**DEFENSE NUCLEAR FACILITIES
SAFETY BOARD**

**DEFICIENCIES IN DOE STANDARD 5506-2007,
*Preparation of Safety Basis Documents for Transuranic
(TRU) Waste Facilities***

**Defense Nuclear Facilities Safety Board
Technical Report**

February 2018

Figure 1. Results of Monte-Carlo statistical sampling test of the MAR algorithm for the case of a uniform MAR distribution, using inventory sizes of $N = 100$ and $N = 1000$.

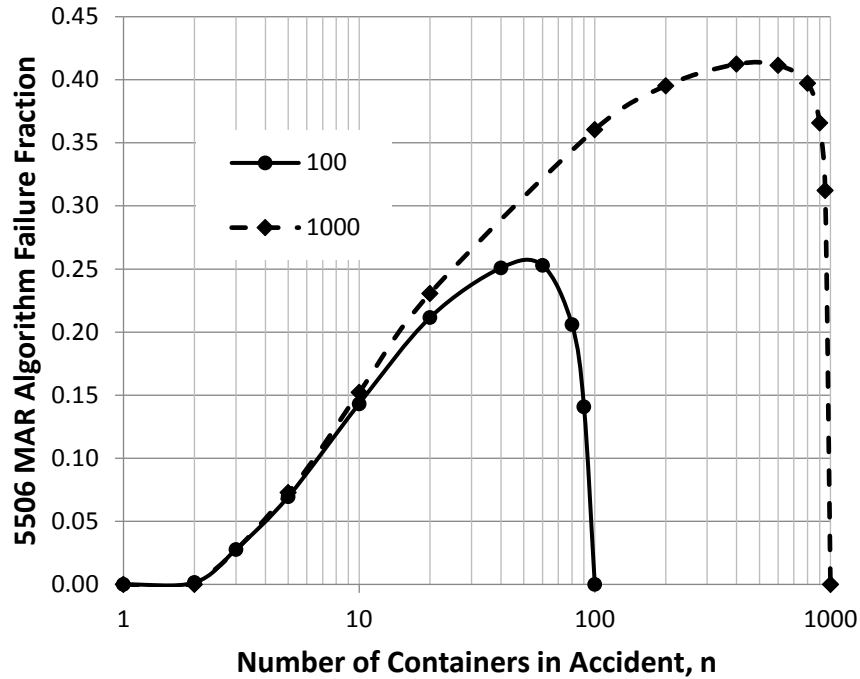
Figure 1 shows the results of the staff’s statistical test for the case of a uniform distribution of MAR within an inventory of waste containers. The staff considered two inventory sizes, $N = 100$ and $N = 1000$. The staff performed approximately 20,000 Monte-Carlo sampling trials to obtain each data point shown. The horizontal axis in Figure 1 shows the number of containers involved in the accident, n . The vertical axis shows the failure fraction of the statistical MAR algorithm. Figure 1 shows that the algorithm does not bound the sampled MAR anywhere in the range $1 < n < N$. Any time the failure fraction (fraction of cases where the algorithm does not bound the actual sample) is greater than zero, it means the algorithm does not bound the actual sample for a percentage of tests in the Monte-Carlo statistical sampling tests. The failure fraction exceeds 15 percent for a sample size of 11 to 89 drums out of a given inventory of 100 containers. The failure fraction exceeds 40 percent for a sample size of approximately 200 to 800 drums out of a given inventory of 1000 containers. The Board’s staff also evaluated other distributions of MAR inventories, including Gaussian, lognormal, and skewed, and obtained similar results.

- The Board's staff determined that the statistical MAR methodology outlined in DOE Standard 5506-2007 is not bounding, and is therefore not consistent with DOE Standard 3009-2014, which requires a bounding MAR to be used in hazard and accident analysis. Statistical tests performed by the Board's staff suggest that the statistical MAR methodology may have a high fraction of cases where it fails to bound actual MAR values.

- Regardless of the conservatism inherent in the statistical MAR methodology, or any improvements made to the algorithm, a requirement that the analyzed MAR bound the actual MAR in a given location would remove the potential for a non-conservative statistical-based MAR.

Figure 2. Variation of the mean MAR among rooms at WIPP.

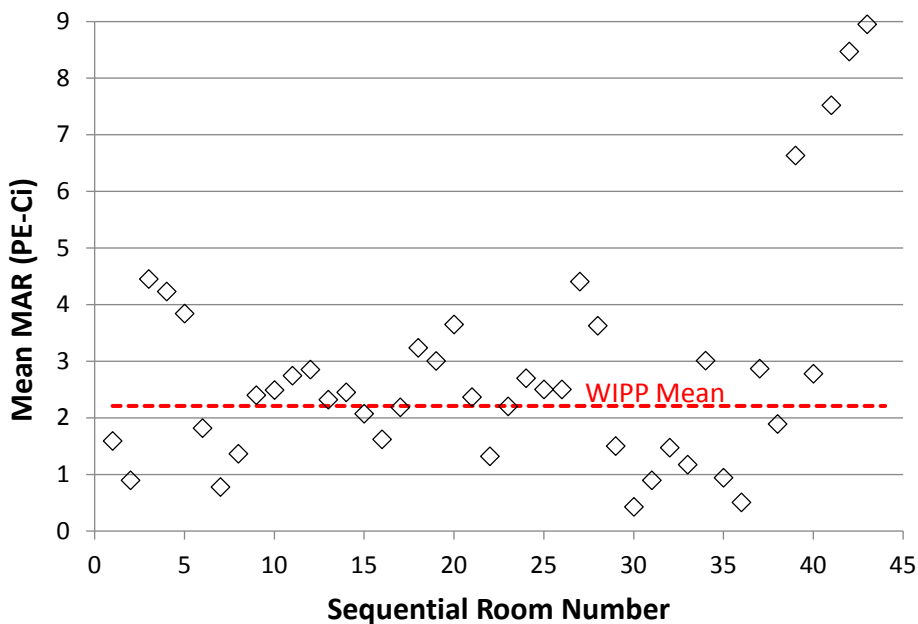
Evaluation of WIPP Inventory—The Board’s staff evaluated how the quantity of MAR in emplaced 55-gallon drums varies within the underground at WIPP. The staff calculated the mean MAR in 55-gallon drums for each of the 43 rooms in the WIPP underground. Figure 2 shows the calculated mean MAR in 55-gallon drums by room number. The dashed line shown in Figure 2 is the mean MAR for all 55-gallon drums at WIPP, 2.21 plutonium equivalent curies (PE-Ci). WIPP uses the mean MAR for all 55-gallon drums underground at WIPP when applying the statistical MAR methodology. However, Figure 2 shows that the mean MAR per room varies considerably in the WIPP underground. The Board’s staff concluded the variability in MAR per room is not random statistical variation, since the rooms contain a large number of drums (approximately 2,000 per room on average). The results shown in Figure 2 suggest that bias associated with individual waste transfer campaigns from different sources contributed to the variation. The staff’s conclusion calls into question the conservatism of the statistical MAR methodology, which relies on the global mean MAR to compute the MAR involved in a localized accident.

- The staff's analysis of MAR in the WIPP underground demonstrates that relying on global waste inventory for formulation of key inputs to the statistical MAR algorithm in DOE Standard 5506-2007 may not be appropriate.

Figure 3. DOE Standard 5506-2007 interpretation of aircraft and vehicle crash assumptions.

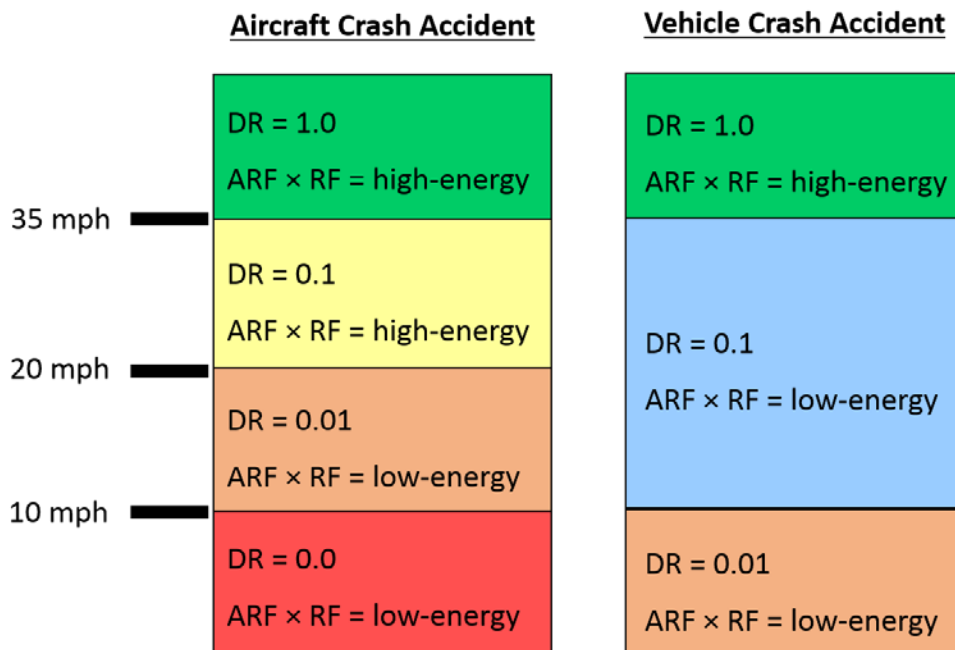
The guidance in DOE Standard 5506-2007 for estimating a radioactive material release due to a vehicle crash or aircraft crash into TRU waste containers does not provide sufficient detail to ensure consistent and conservative application across all TRU waste facilities. Furthermore, the lack of detail has contributed to inconsistent application of damage ratio and airborne release fraction times respirable fraction (ARF×RF) values for vehicle and aircraft crashes. Figure 3 illustrates how aircraft and vehicle crash accidents have applied different combinations of damage ratio and ARF×RF as a function of impact velocity, based on interpretation of guidance provided in DOE Standard 5506-2007.

Low-Energy vs High-Energy vs Catastrophic Impacts—The ARF×RF values cited in DOE Standard 5506-2007 can differ by an order of magnitude, based on whether they are classified as low-energy or high-energy impacts. DOE Standard 5506-2007 states that the high-energy impact ARF×RF values are applicable to a container fall from the fifth tier of stacked drums. This equates to a fall height of approximately 13.7 feet. A 13.7-foot fall height results in an impact velocity of approximately 20 miles per hour. A commonly used method in the aircraft crash accident analysis is to use the impact velocity calculated for a 13.7-foot fall height (i.e., 20 miles per hour) as the threshold above which high-energy impact ARF×RF values are applied.

When evaluating ground vehicle crash accidents, the high-energy impact ARF×RF values are generally not applied unless vehicle speeds are expected to be greater than 35 miles per hour, which is inconsistent with the 20 miles per hour threshold commonly used in aircraft crash

The damage ratios recommended in DOE Standard 5506-2007 differ by an order of magnitude, based on whether the impact is a result of a moderate to severe stress or a catastrophic stress. DOE Standard 5506-2007 assumes a catastrophic stress to be the result of an impact speed greater than 35 miles per hour. However, DOE Standard 5506-2007 does not offer guidance to the user on how to account for differing vehicle mass and size. The kinetic energy and momentum of the vehicle depends on both the mass and speed. Determination of the maximum possible vehicle speed at the facility is not standardized since DOE Standard 5506-2007 allows for speed restrictions due to the “physical layout of the facility/size and associated obstacles.” While the physical layout needs to be considered to evaluate a credible event, a formalized process for determining the potential maximum speed would improve how the physical layout and/or obstacles are used to define the initial conditions of the event. Similar to the vehicle barrier analysis performed for TWPC [7], a parametric evaluation could be performed using the known distances available for vehicle acceleration before impacting a waste container. The parametric evaluation could consider the possible vehicle types and account for varying acceleration estimates for each vehicle type.

In addition, the application of a zero damage ratio for impacts occurring at less than 10 miles per hour has been inconsistently applied between aircraft and vehicle crash accidents. Aircraft crash accident analysis at ORNL–TWPC [6] applies a zero damage ratio once enough momentum has been transferred to waste containers to slow down the aircraft and impacted waste containers to 10 miles per hour. Application of a zero damage ratio for impact speeds less than 10 miles per hour is based on the 4 foot drop qualification for Department of Transportation Type A containers, which equates to an impact velocity of 10 miles per hour. Appendix C of DOE Standard 5506-2007 endorses the use of a zero damage ratio for drums that fall less than 4 feet. However, Appendix C then defines low speed vehicle impacts as occurring at less than 10 miles per hour and recommends applying a damage ratio of 0.01. As a result, the source term assumptions for low speed impacts (10 miles per hour or less) differ depending on whether the impact is initiated by an aircraft or a vehicle.

DOE Standard 5506-2007 should clearly provide the thresholds that determine which damage ratio and ARF×RF should apply to both the aircraft and vehicle crash accidents, such that application is consistent for all relevant accident scenarios. Multiple variables must be

- Establishing thresholds that define the severity of impact stresses, and
- Selecting assumptions and methods for evaluating vehicle and aircraft impacts on TRU waste facilities and containers.
